REFERENCE NO: RF-17-03

SUBJECT: 2013-2015 CX-5 – NEW MOUNTING BOLT FOR FRONT BUMPER

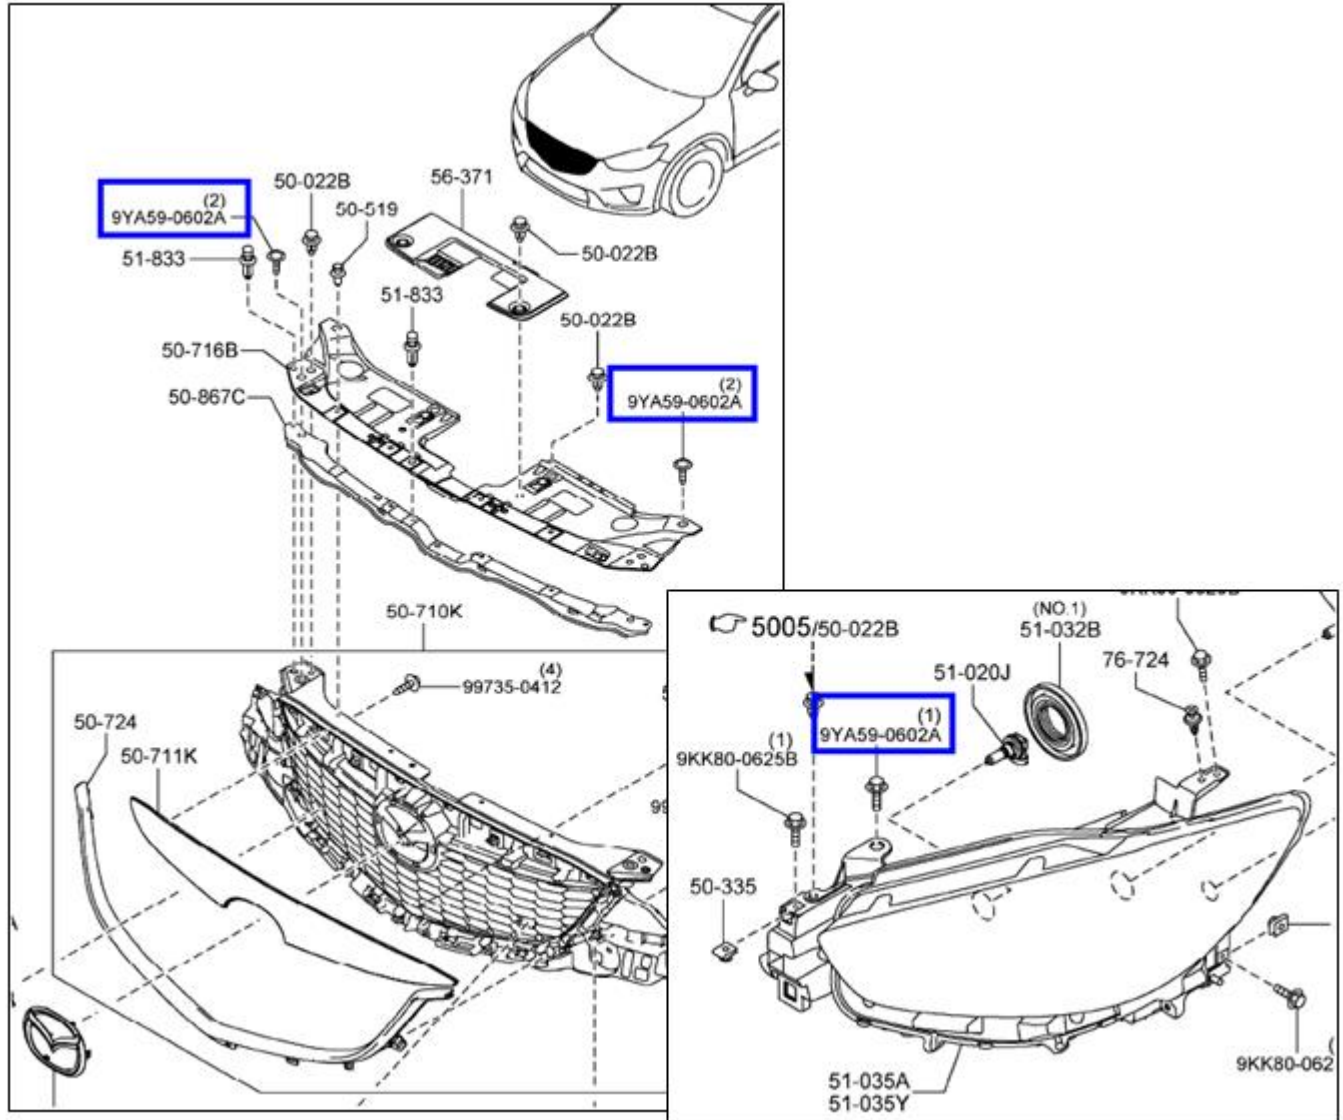
A newly established mounting bolt (P/N KD45-50-0Z2) has been released to provide extra durability when mounting the front bumper. Use KD45-50-0Z2 in place of 9YA5-90-602A when needed.

- This bolt is non-reusable due to the thread-locking fluid. Always use new ones when installing the front bumper.
- Tightening torque is the same as the original bolt.
